PREESE HALL SHALE GAS FRACTURING

REVIEW & RECOMMENDATIONS FOR INDUCED SEISMIC MITIGATION

We have been asked by DECC to review these reports, and the further studies and information provided by Cuadrilla; and to make appropriate recommendations for the mitigation of seismic risks in the conduct of future hydraulic fracture operations for shale gas.

Figure 1: Graphs showing a) variations of analysed parameters with depth and b) overlain prefrac surface treating pressure plots.

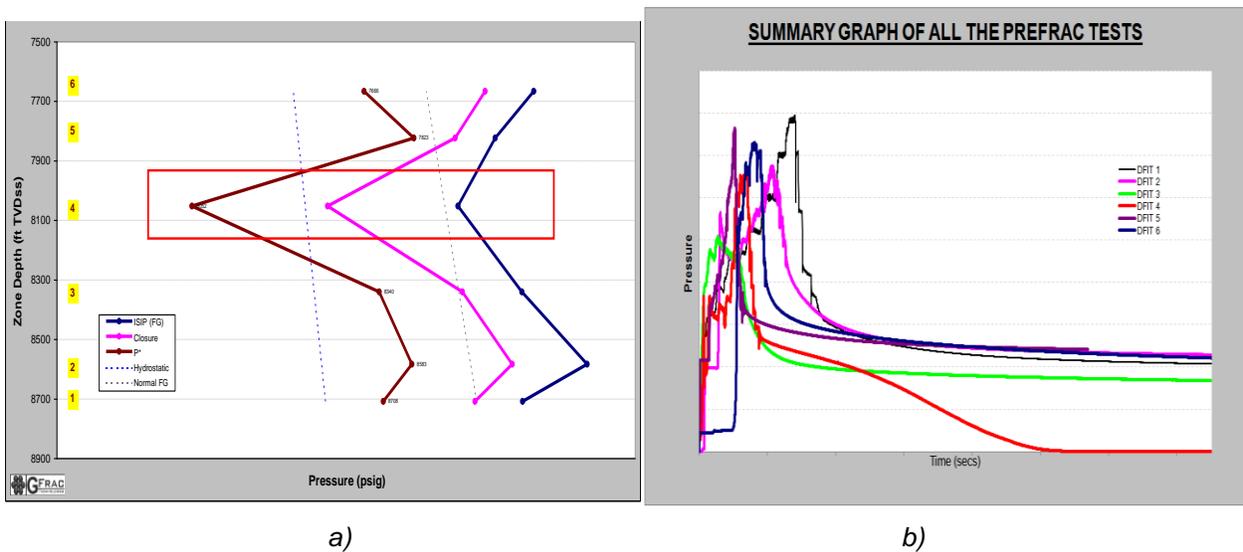
The plots of the treatment variations with depth are shown in Figures 1a) and 1b) and the only obviously exceptional zone is zone 4, as highlighted in Figure 1a. Zone 4 prefrac injection test analysis indicates that the fracture grew into a much lower stress zone and exhibited "fracture height recession" type leak-off characteristics, here probably representing the created fracture being forced into high-stress impermeable layers, which are forced to close first. We interpret this as possibly being at, or very near, to the fault, which is then proposed as a possible explanation of the subsequent immediate seismic events, while injecting into zones 4 and 5.

Overall, the results indicate distinct and separate behaviours for each zone, interpreted as being representative of good containment of the created fracture growth in each zone. However, we consider that there is little additional useful information that can be concluded about the resultant fracture growth using only the surface job data, given the lack of complementary diagnostics.

Figure 3: Woodford shale measured fracture heights compared to aquifer depths (copyright SPE)

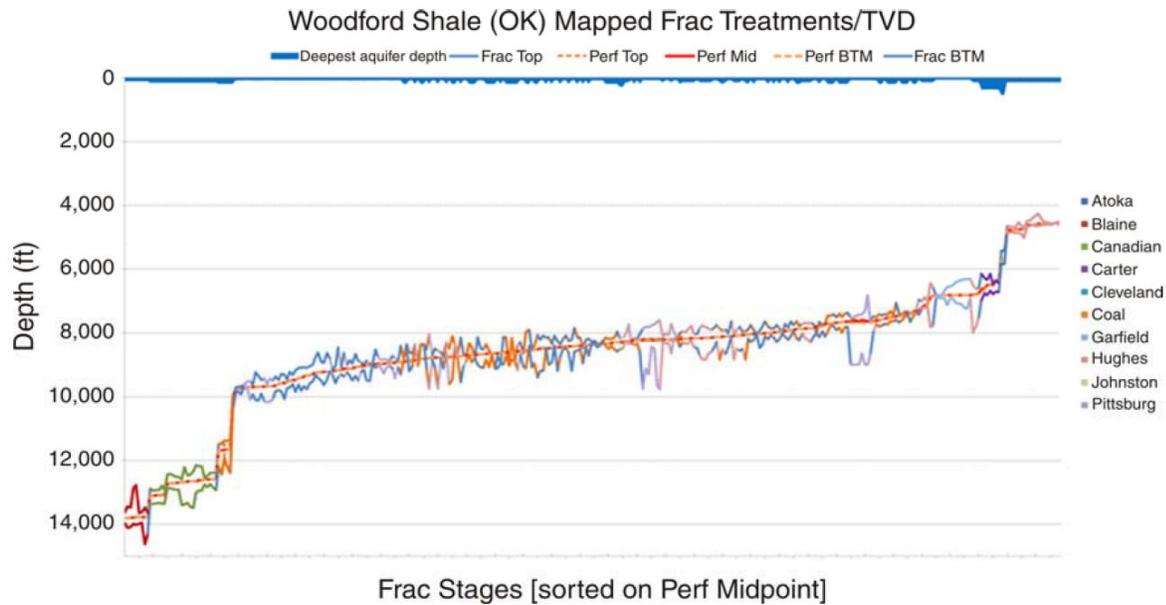
One of the major concerns with shale gas developments is answering the question of how the created hydraulic fracture grew, particularly in relation to shallower aquifers. A summary of US microseismic and tiltmeter data in shales has recently been published (Fisher and Warpinski, 2011) based on treatments carried out in the Barnett, Woodford, Marcellus and Eagle Ford shales. This work is of particular interest as it summarises how the fractures grew with respect to the overlying aquifers. Overall, the data indicate that in general for deeper shales (here classified as >4000ft TVD_{SS}), the created hydraulic fractures remain well confined to the target interval, even in the presence of faults, (see Figure 3 and also Figures 4-6).

Overall, the US data indicates that faults do not provide a mechanism whereby created fractures are able to propagate significantly upwards, towards the surface. The presence of faults is generally indicated by large upward and downward growth spikes, but overall vertical growth is still limited to several hundreds of feet. The Woodford shale is probably the best analogue for the Bowland shale, as it also has a very complex geology which also includes faulting and highly dipping or overturned bedding planes. However, interpretation of the

Woodford, in common with the Barnett, shows that created hydraulic fracture heights are well contained and separated from the local aquifers by at least several thousand feet. (In US regulatory practice, the focus would be on protection of aquifers used, or potentially usable, for drinking water supplies. It is our understanding that in the UK, the Environment Agency would aim to secure appropriate protection of all groundwater.)
